HIGHWAY WORK PROPOSAL

<u>COUNTY</u>	<u>STATE PROJECT</u>	<u>FEDERAL</u>	<u>PROJECT DESCRIPTION</u>	<u>HIGHWAY</u>
Winnebago	4992-03-71	WISC 2020384	Racine Street Bridge, C Of Menasha; Fox River Bridge And Approaches	LOC STR

Addendum No. 01
ID 4992-03-71
Revised Sheet 15
July 30, 2020

Addendum No. 01
ID 4992-03-71
Revised Sheet 550
July 30, 2020

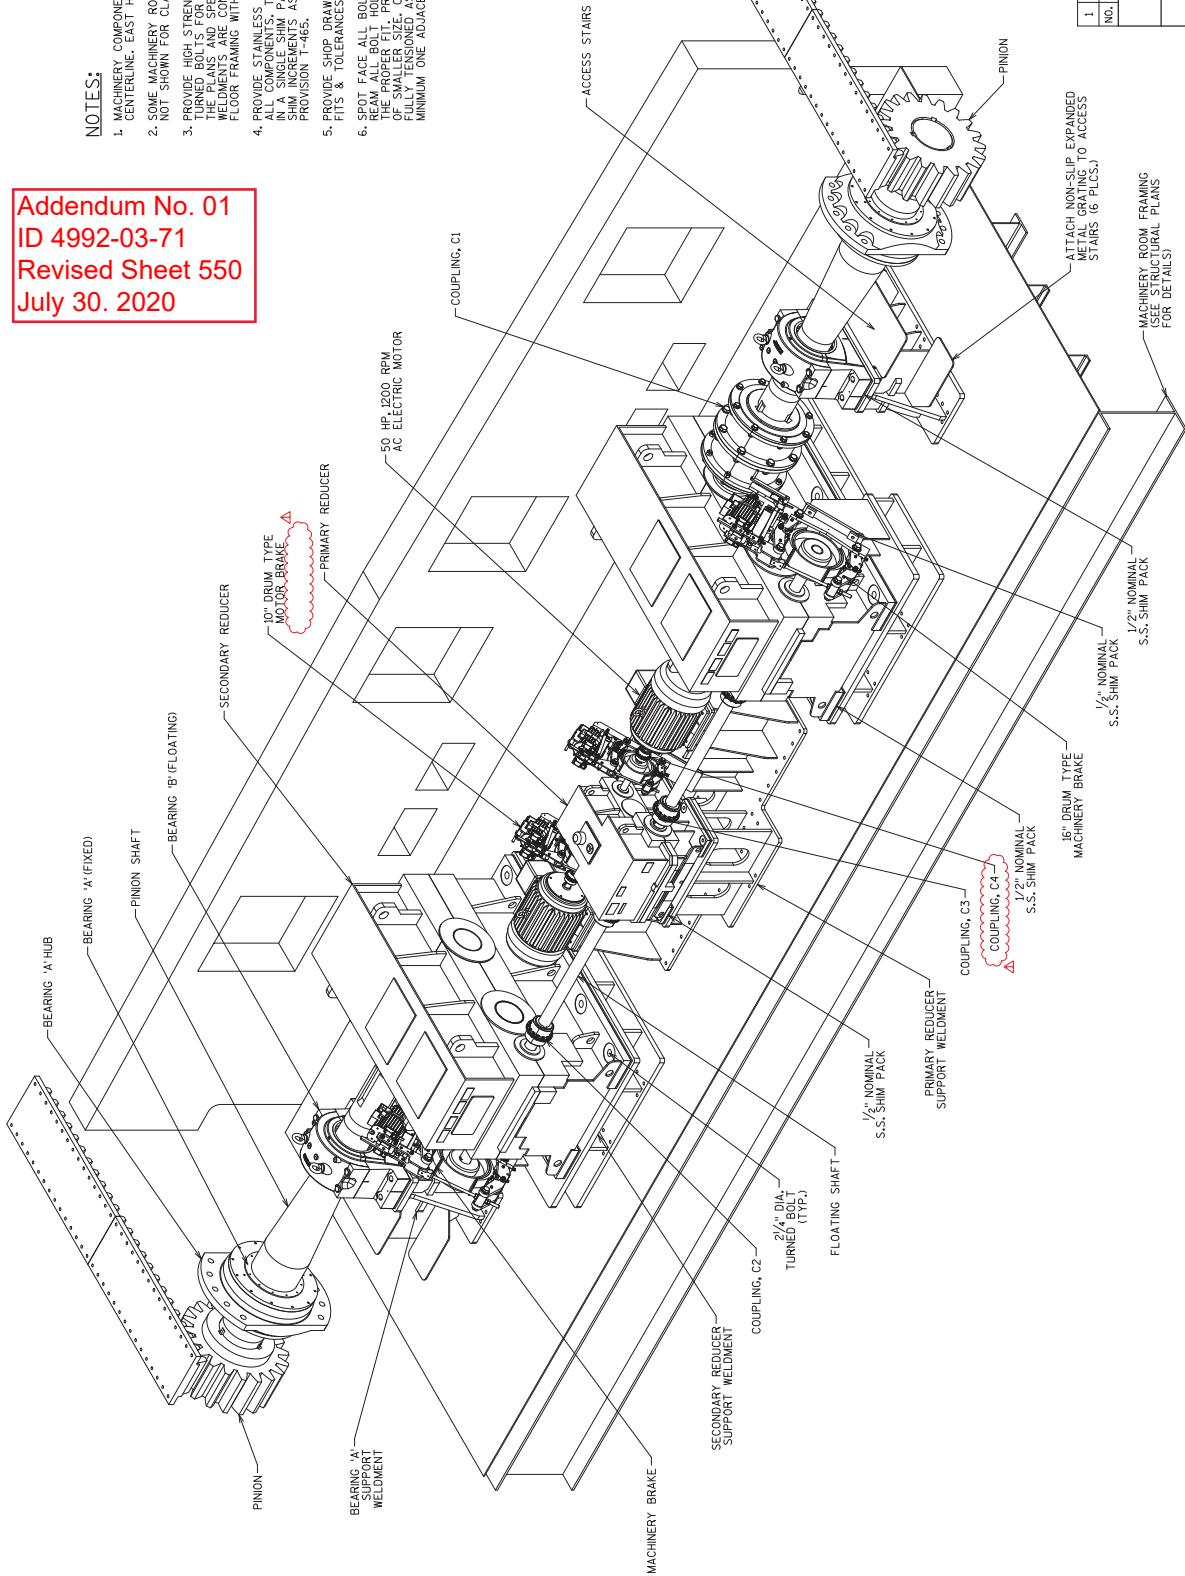
1	7/20	ADDED COUPLING C4	JCU
NO.	DATE	REVISION	BY
STATE OF WISCONSIN DEPARTMENT OF TRANSPORTATION STRUCTURES DESIGN SECTION			
STRUCTURE B-70-324			
DRAWN BY		JCU	PLANS #
CHECKED BY		JCU	DRAWING
			M 2 OF M19
MACHINERY TRIMETRIC VIEW			550

Addendum No. 01
ID 4992-03-71
Revised Sheet 551
July 30, 2020

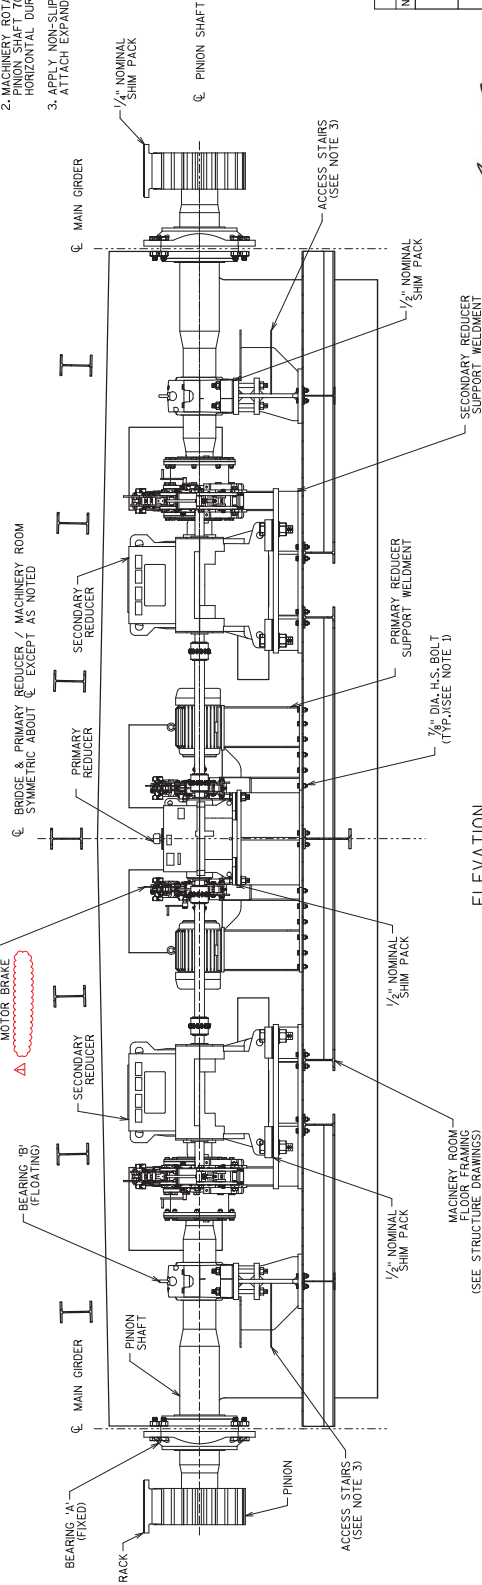
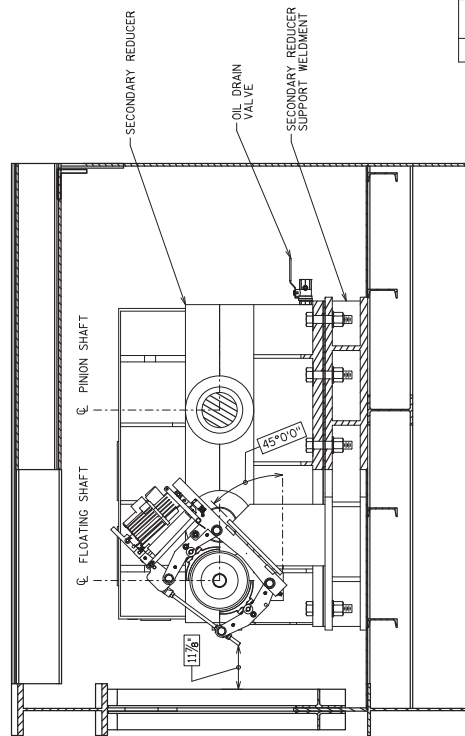
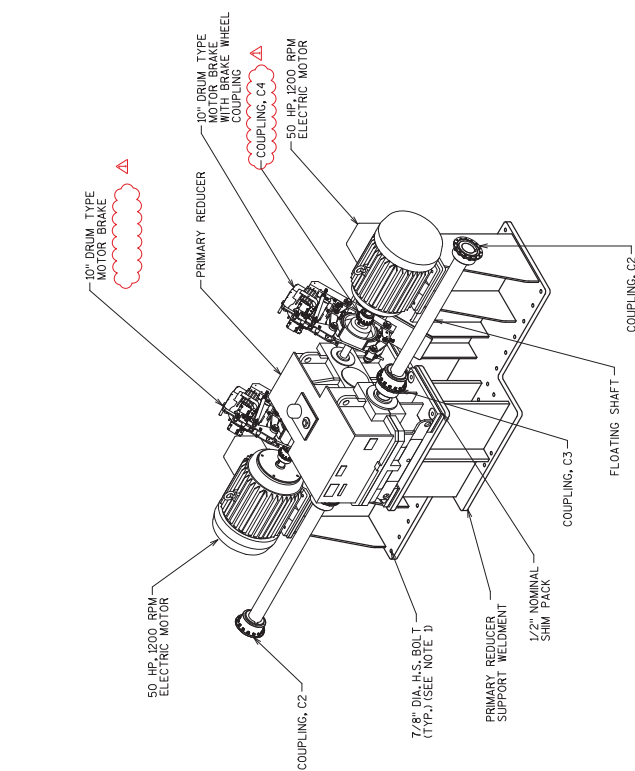
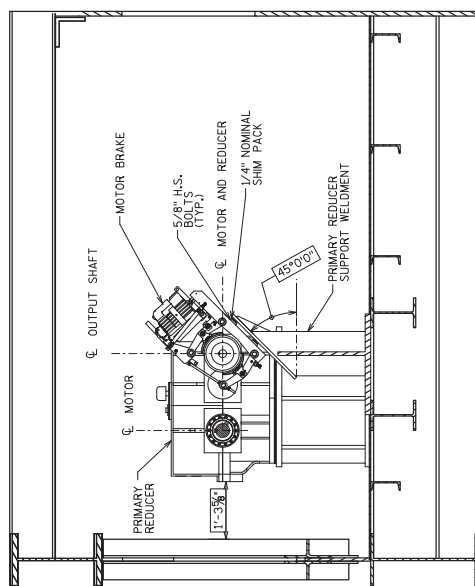
NO.	DATE	REVISION	BY	JCU
1	7/20	ADD COUPLING C4, BRAKE DESC.

Addendum No. 01
ID 4992-03-71
Revised Sheet 552
July 30, 2020

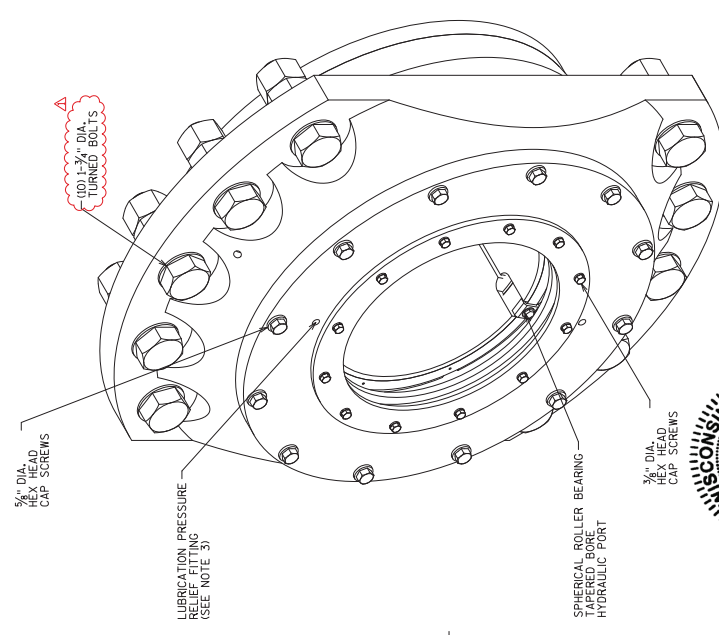
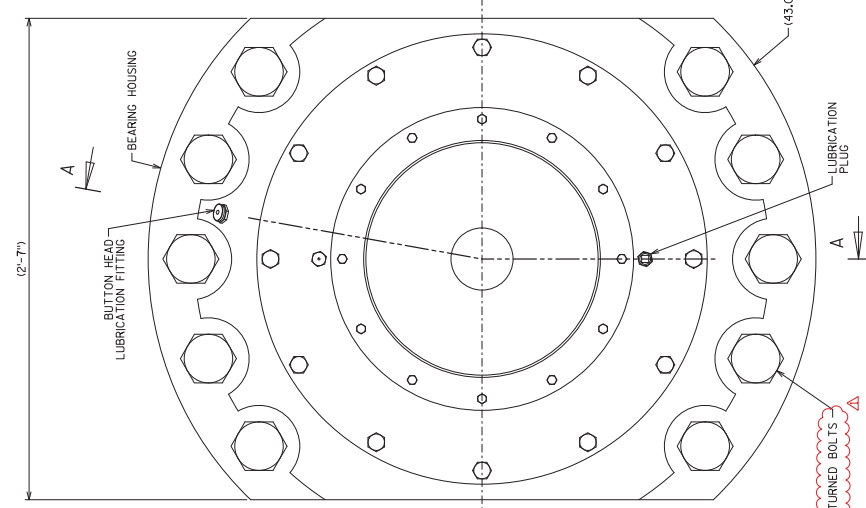
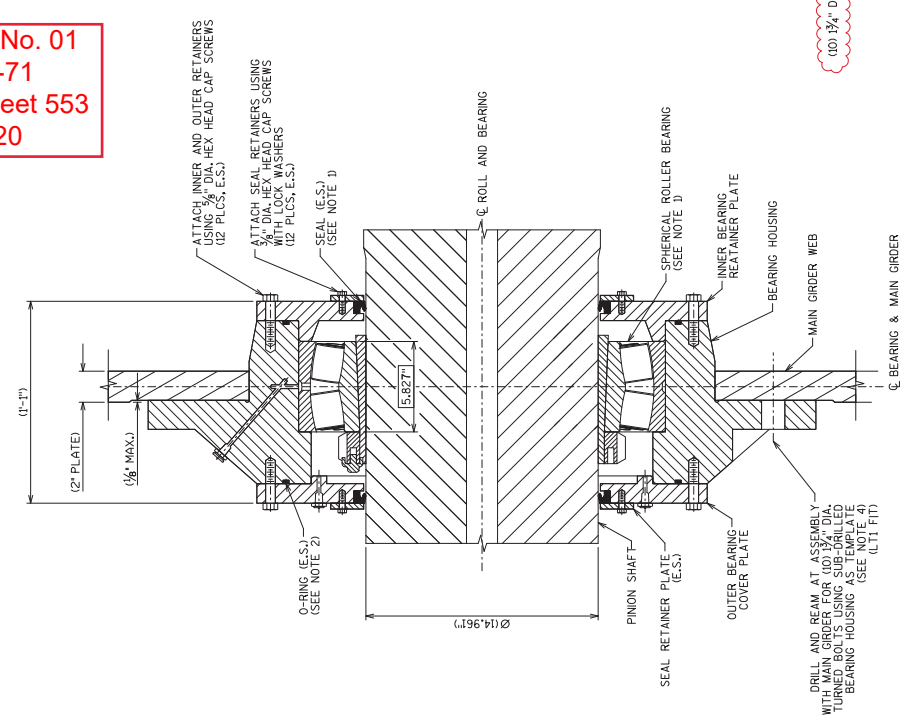
1	7/20	ADDED COUPLING C4, BRAME DESC.	JCU
NO.	DATE	REVISION	BY
STATE OF WISCONSIN DEPARTMENT OF TRANSPORTATION STRUCTURES DESIGN SECTION			
STRUCTURE B-70-324			
DRAWN BY		JCU	* PLANS EXD.
MACHINERY PLAN & ELEVATION 2			DRAWING M4 OF M19
			552

Addendum No. 01
ID 4992-03-71
Revised Sheet 594
July 30, 2020

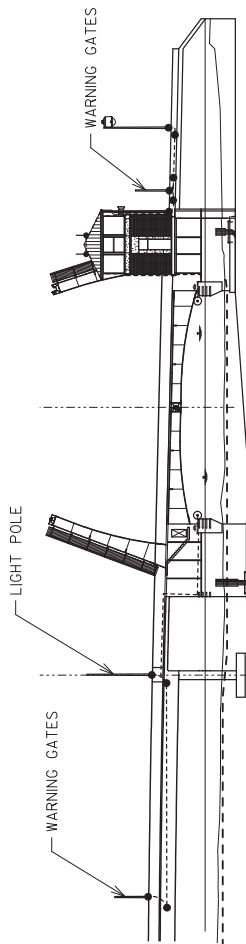
1	3/7/2020	REVISED NOTE 5	HWP
NO.	DATE	REVISION	BY
STATE OF WISCONSIN DEPARTMENT OF TRANSPORTATION STRUCTURES DESIGN SECTION			
STRUCTURE B-70-324			
GROUNDING AND LIGHTNING		PLANS BY	DAD CKO.
PROTECTION DETAILS		DRAWING E27 OF E64	
		594
